**CITY OF TEMPE
DEVELOPMENT REVIEW COMMISSION**

**Meeting Date: 08/12/2014
Agenda Item: 2**

ACTION: Request for a Development Plan Review consisting of a new 2,961 s.f. restaurant with drive-through for POPEYE’S LOUISIANA KITCHEN, located at 1615 West Elliot Road. The applicant is SBL Engineering LLC.

DPR14117 Development Plan Review including site plan, building elevations, and landscape plan.

project #:
2014010
date:
5/8/14
rev. by checked by date
PR
drawn by:
-
drawing title:
NORTH & SOUTH
EXT. ELEVATIONS
drawing number:
DRC2

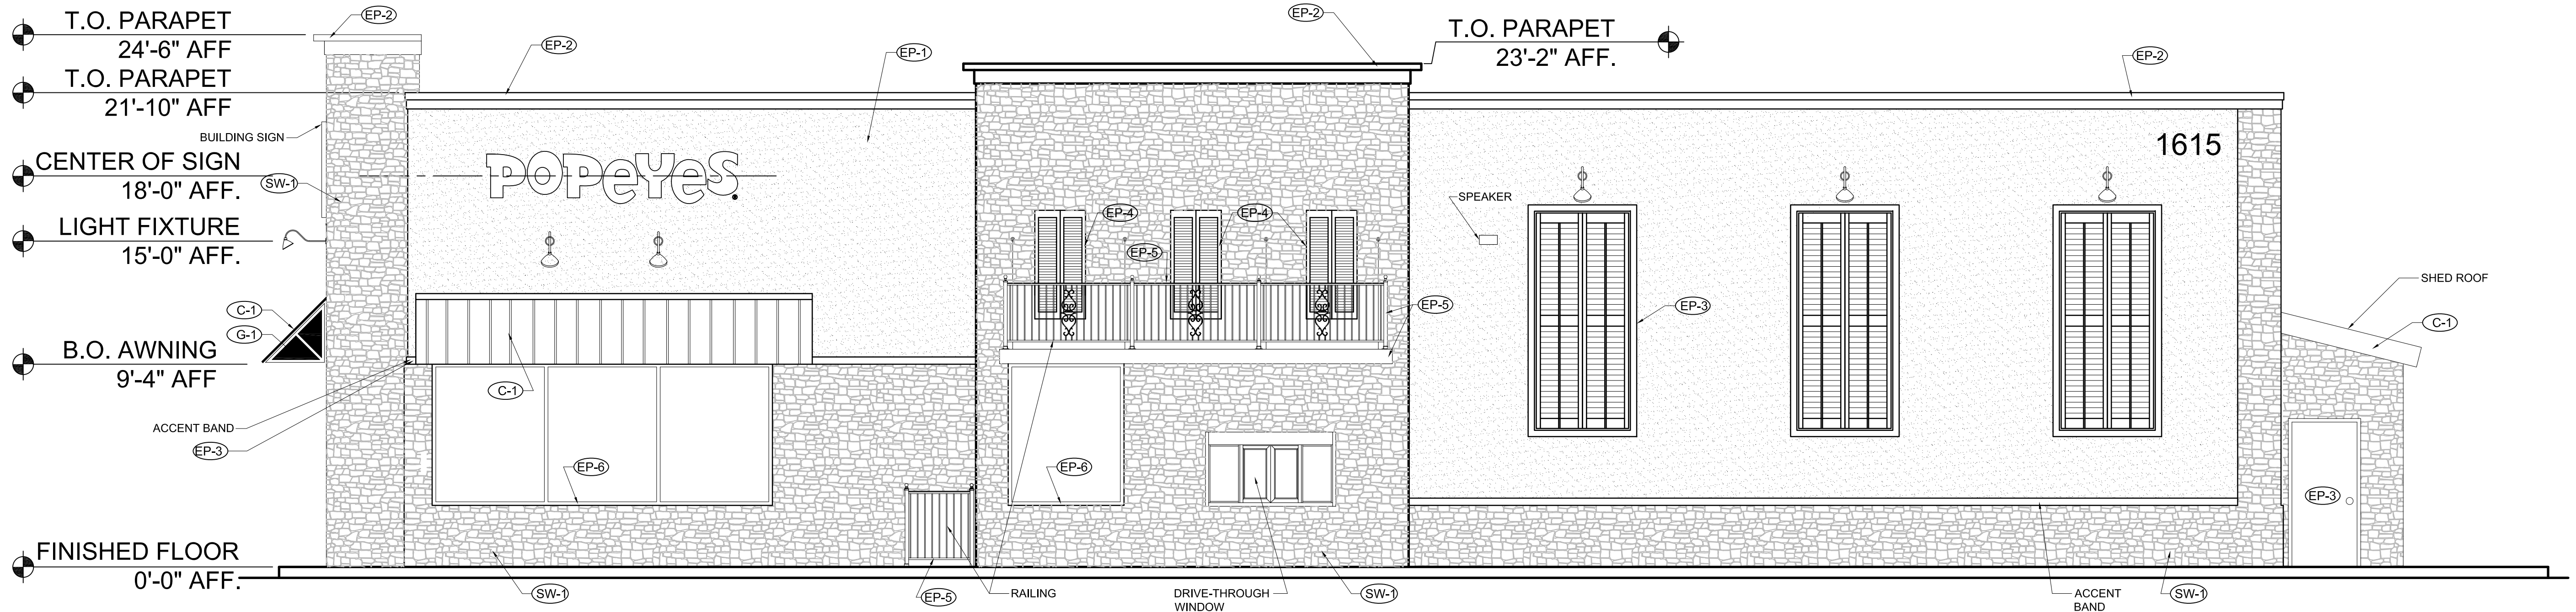
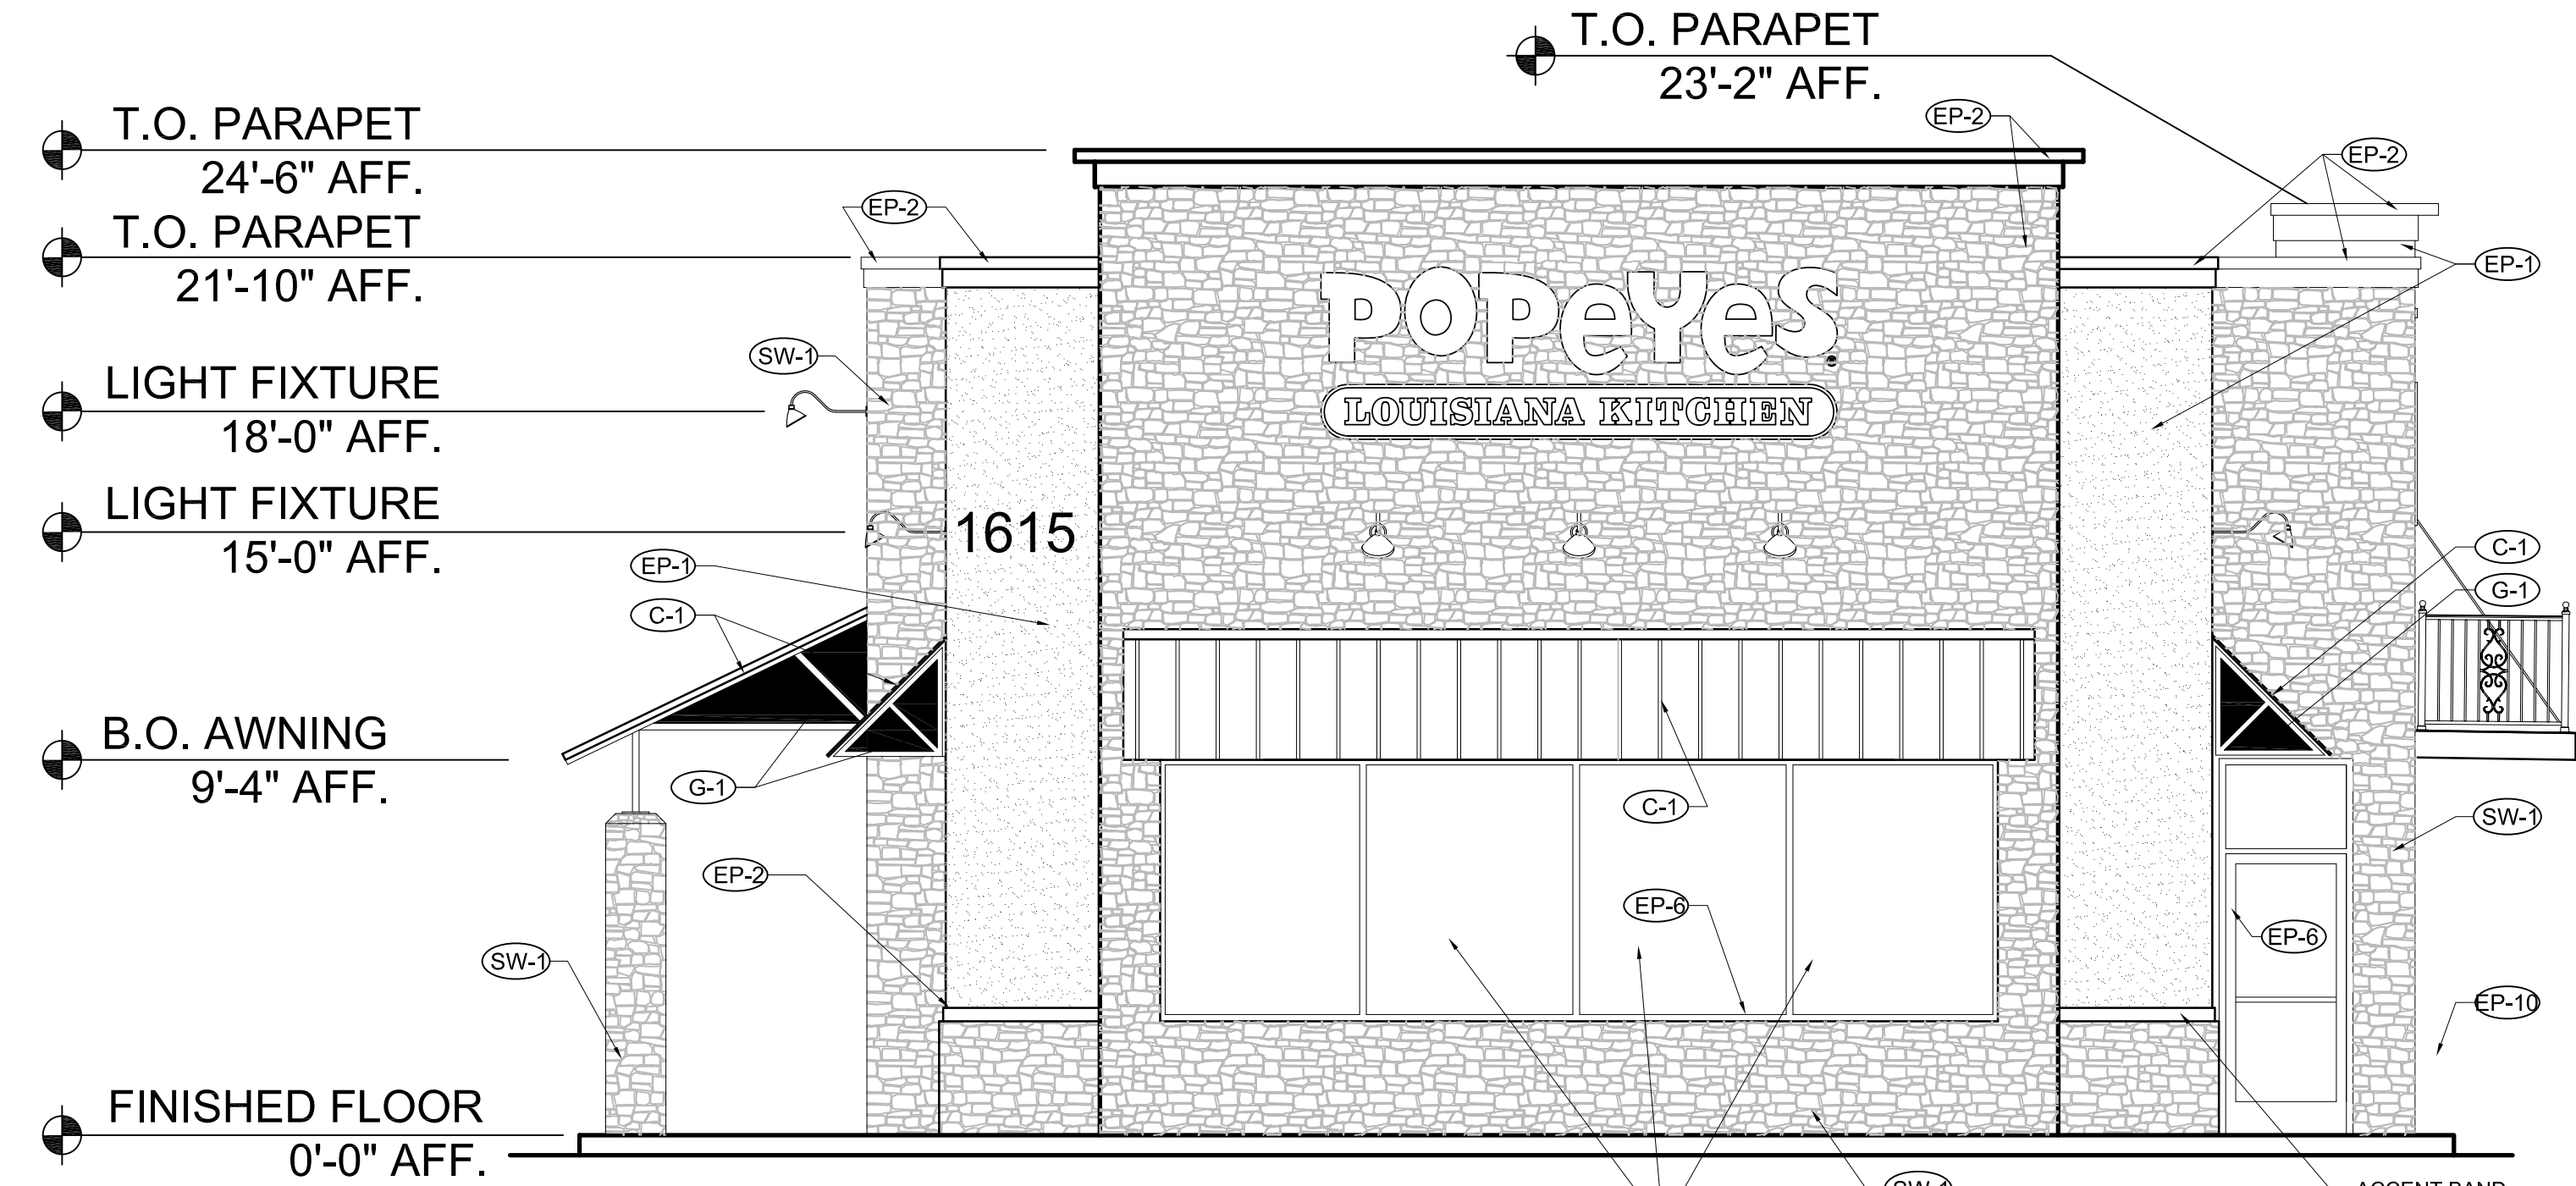
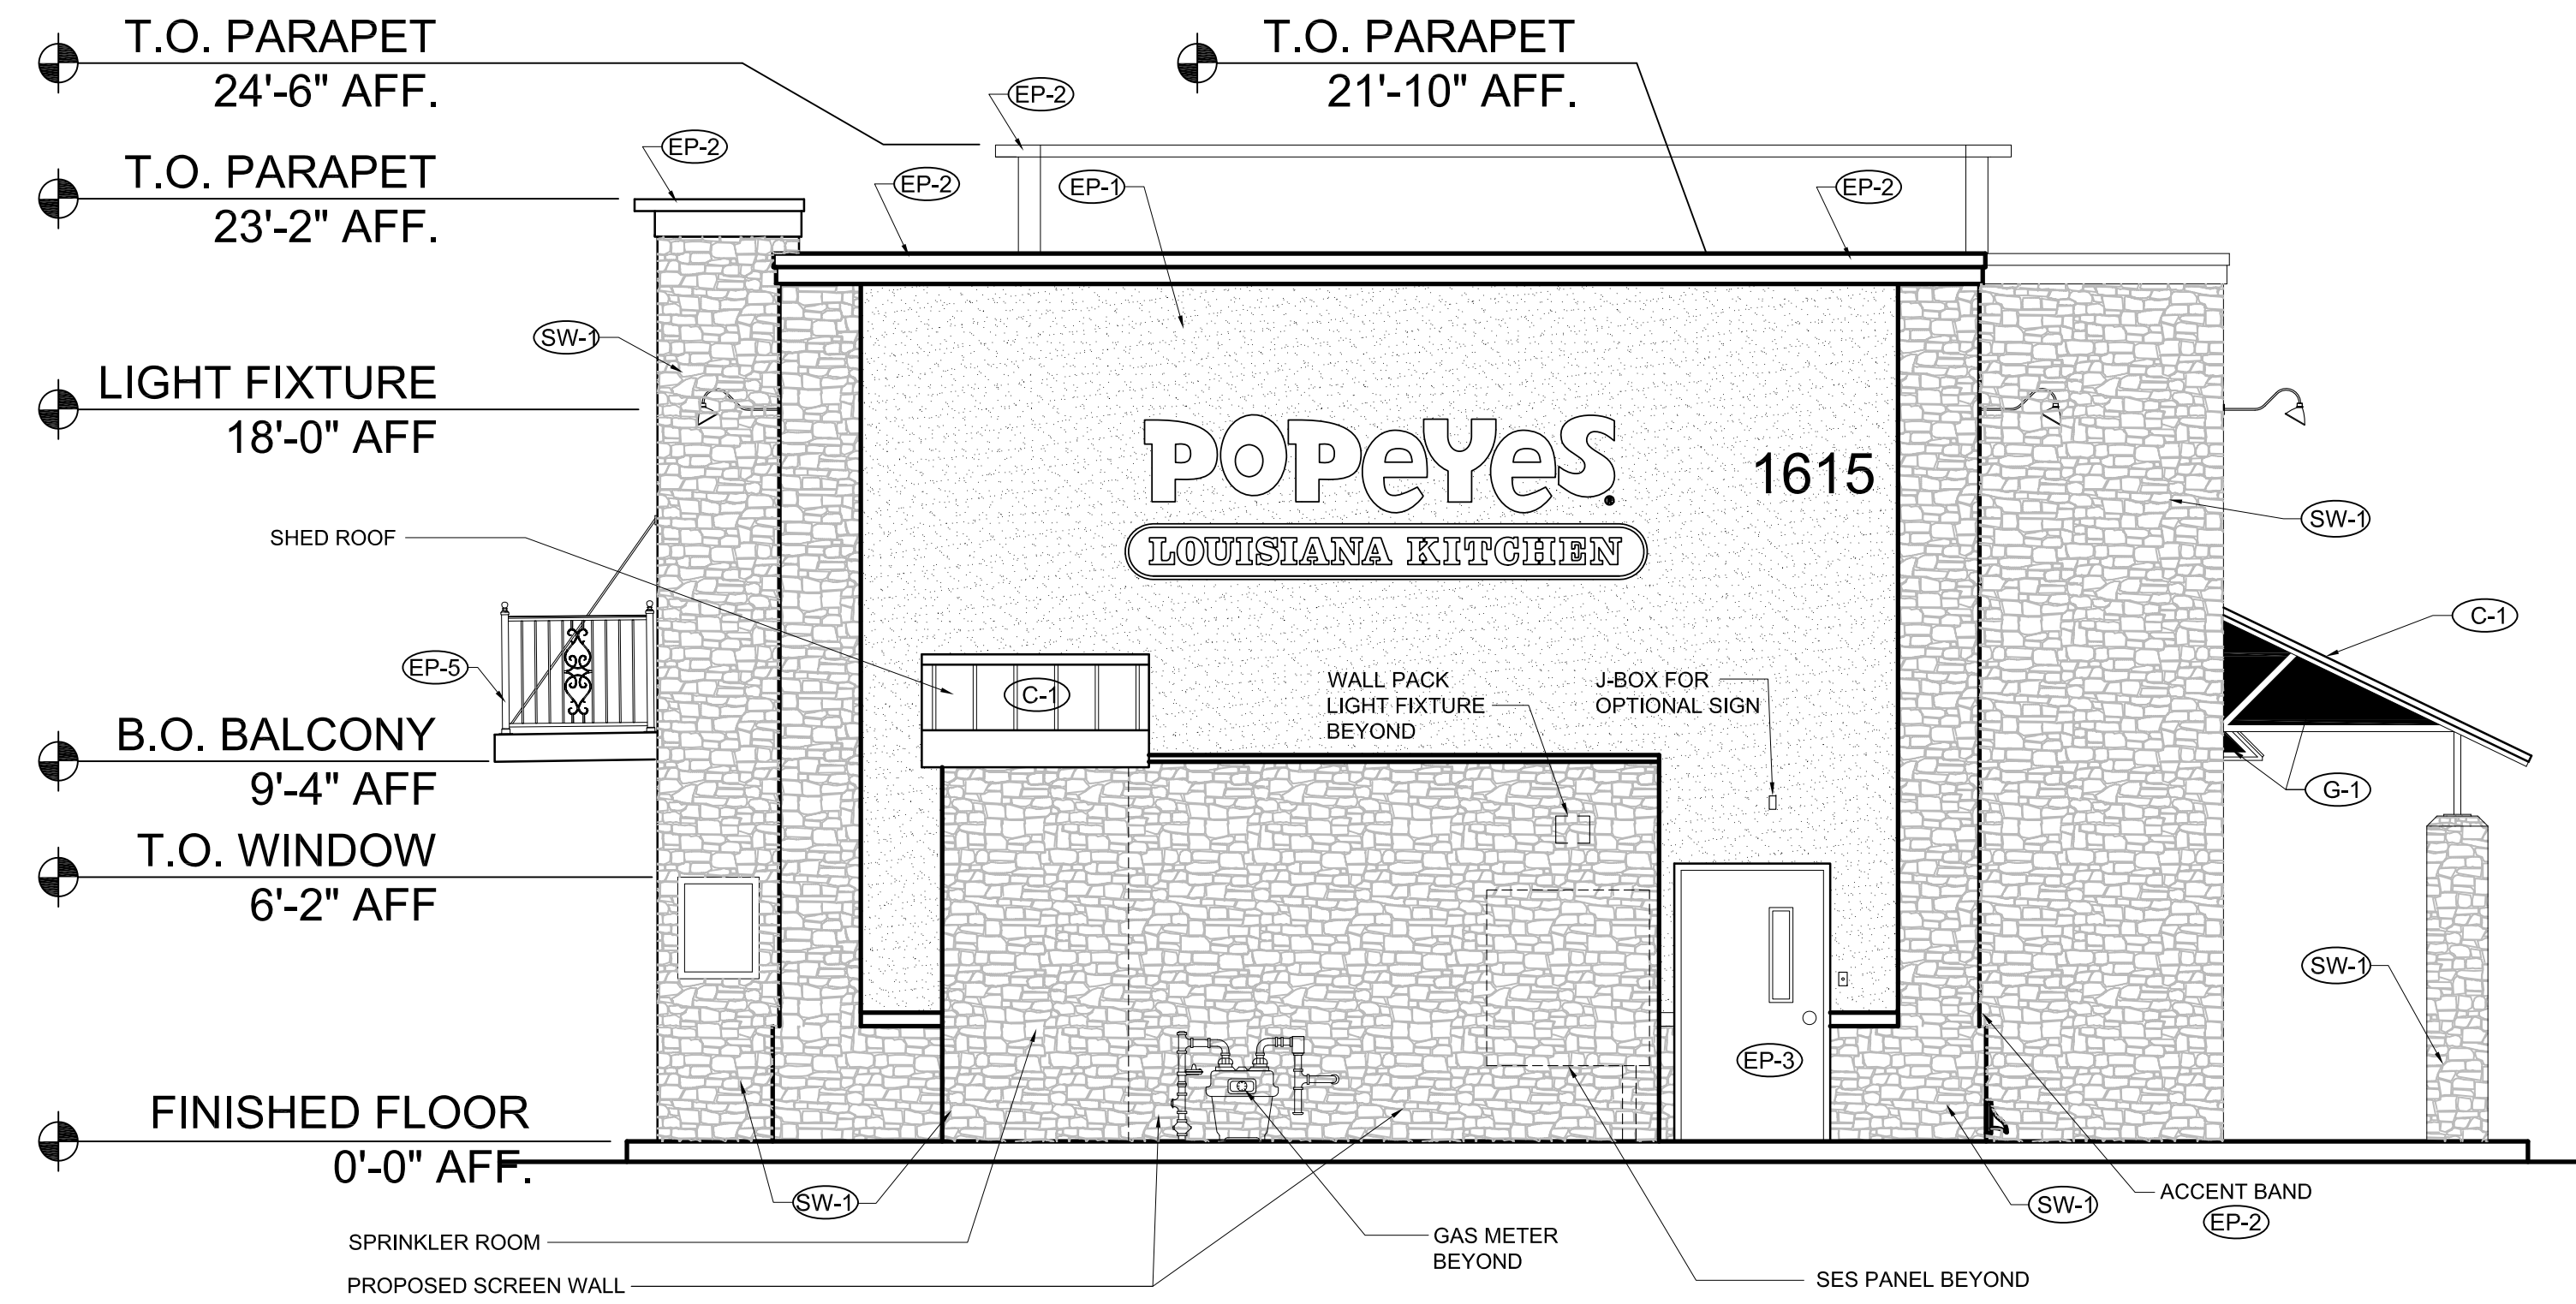
5. The materials and colors are approved as presented:
Main wall surface above accent trim – Benjamin Moore – Delightful Golden #2158-40
Accent trim – Benjamin Moore – Mocha Brown #2107-20
Stone Wainscot – Harrisontone – Unitah Mountain Ledge St. Cloud
Standing Seam Canopies, 12" on-center – Copper Sales, Inc. – Mocha Brown #2107-20
Balcony, railing, and shutters – Benjamin Moore – Mocha Brown #2107-20

6. All canopies shall have solid, metal end caps instead of the proposed awning grates.
7. Provide secure roof access from the interior of the building. Do not expose roof access to public view.
8. Conceal roof drainage system within the interior of the building.
9. Incorporate lighting, address signs, and incidental equipment attachments (alarm klaxons, security cameras, etc.) where exposed into the design of the building elevations. Exposed conduit, piping, or related materials is not permitted.
